Manual Update Sheet

Document Being Updated: *TMS320C54x DSP Reference Set, Volume 1: CPU and Peripherals*

Literature Number Being Updated: SPRU131D

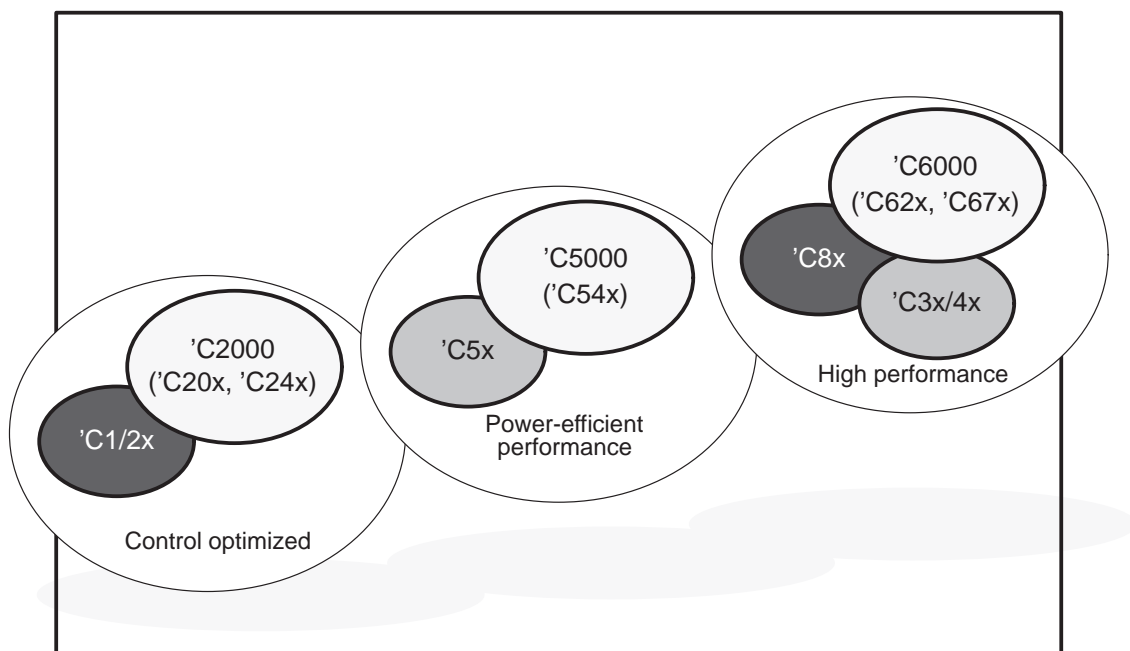
- vi Add the following sentence to the end of the first paragraph:
- Many of these documents are located on the internet at <http://www.ti.com>. Click DSPS Solutions, then click DSP Literature.
- vii Add the following document reference:
- TMS320C548/C549 Bootloader Technical Reference*** (literature number SPRU288) describes the process the bootloader uses to transfer user code from an external source to the program memory at power up. (Presently available only on the internet.)
- 1–3 Change Figure 1–1 , *Evolution of the TMS320 Family*, to the following updated graphic:
